Summary
Total project issues : 55
Total printed issues : 54

688. Mezzanine floor extension**Description:**

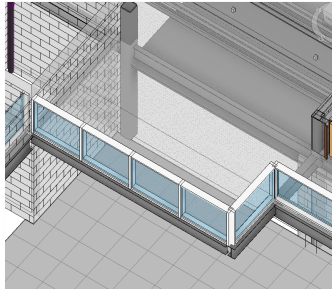
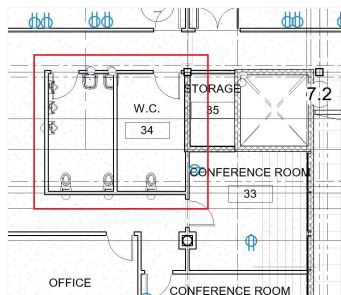
The floor of the mezzanine is enlarged to create a reception area for the lift

Les poutres sont ajustées.

691. Missing roof - part II

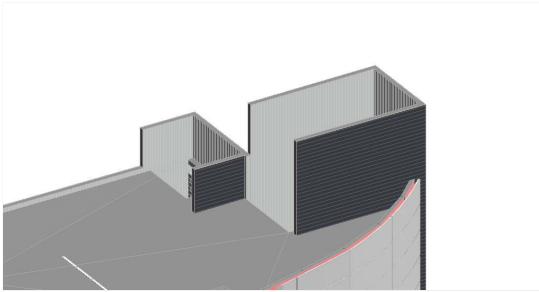
Description: Add missing roofs for roof drains positionning.

USER / DATE	COMMENTS
Mustapha Djaziri 1/26/2018 3:08 PM	retabli
Mustapha Djaziri 1/26/2018 3:08 PM	retabli

690. Missing roof

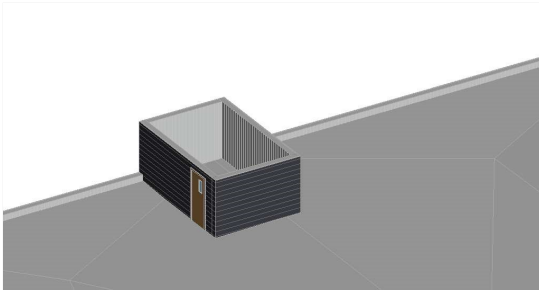
Description: Please add roof for roof drain positionning.

USER / DATE	COMMENTS
Mustapha Djaziri 1/26/2018 3:09 PM	la porte requise un rehaussement en elevation de 200mm par rapport au surface de toit
Mustapha Djaziri 1/26/2018 3:09 PM	la porte requise un rehaussement en elevation de 200mm par rapport au surface de toit

689. Roof Opening

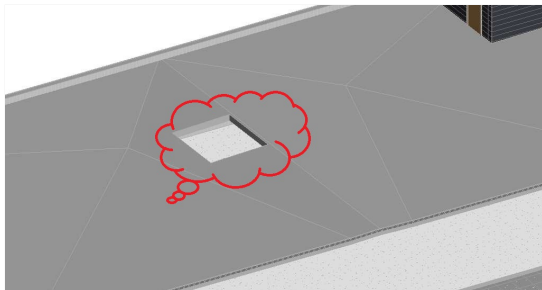
Description: What is this for?

684. Information needed concerning the exterior walls

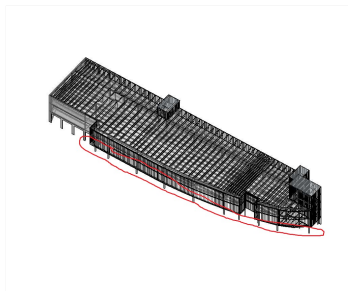
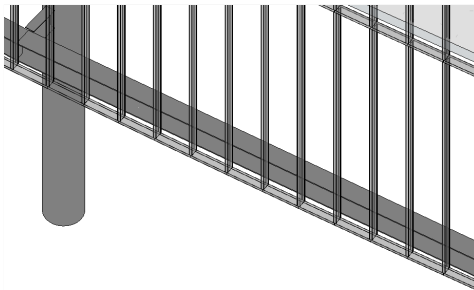
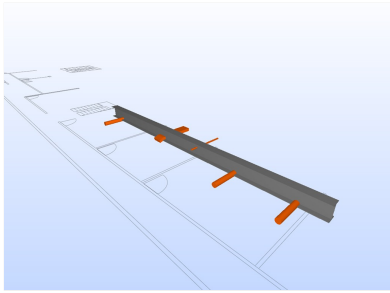
Description: Hi Mustafa, are the base of your walls sitting on the Beams or not? Please let me know ASAP.

Hey Jonas, what do you need exactly? Are you talking about the wall lateral alignment?

724. Beam issue.

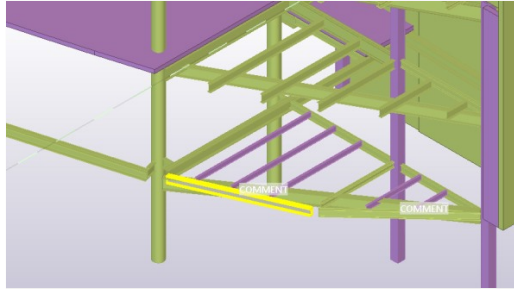
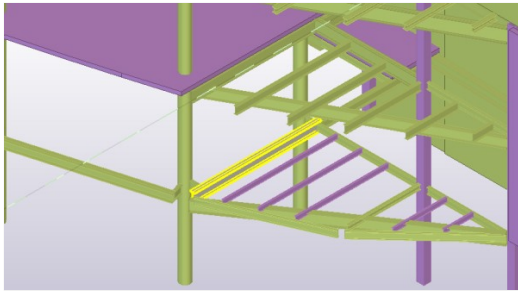
Change beam connection type.

Verify connections at both ends.

723. Check beam connection.

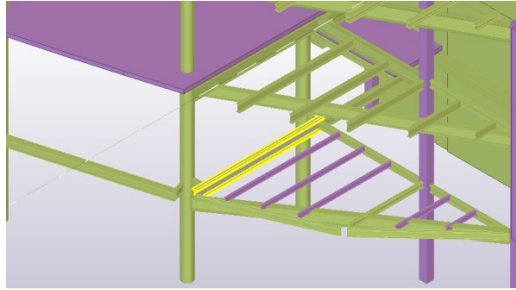
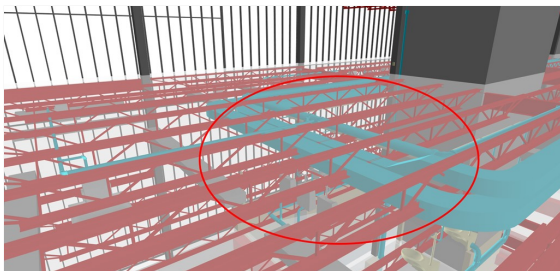
Check beam connection.

Beam size to be changed.

722. Check duct alignment in webs

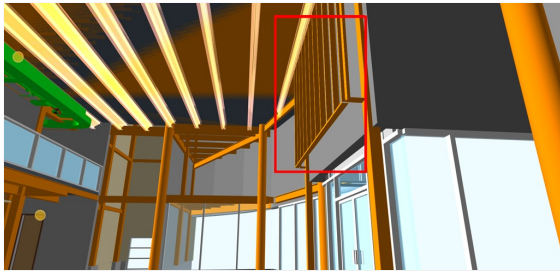
Description: Ducts must be aligned in the joists webs.

Hi all, just doing a quick follow up on this.

685. Check wall joins

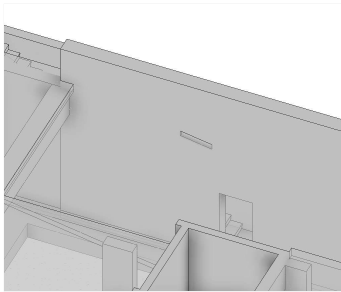
Check wall joins

681. Doors missing

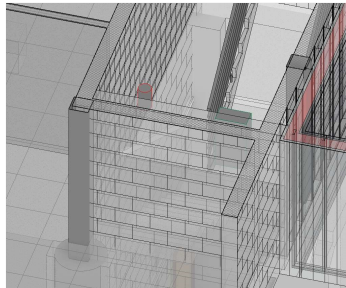
Description: Il manque une porte pour l'ascenseur et une porte piéton

USER / DATE	COMMENTS
Carl Veillette 1/26/2018 10:45 AM	Looks like the door are still missing. Are you guys working on that?
Carl Veillette 1/26/2018 10:45 AM	Looks like the door are still missing. Are you guys working on that?

673. Check door opening

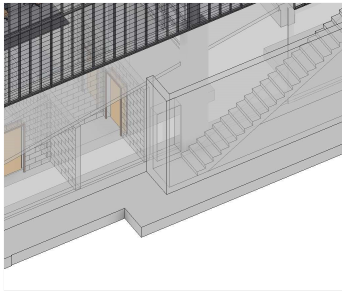
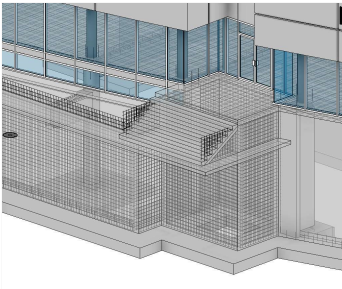
Description: There is a door missing as well as the topo which is badly cut.

659. Weird wall

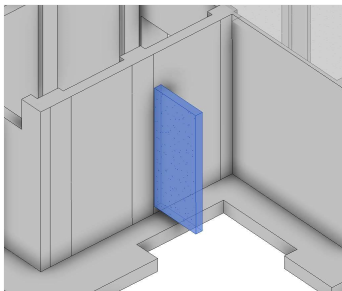
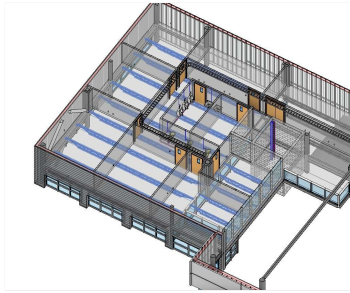
Description: What is the purpose of this wall.
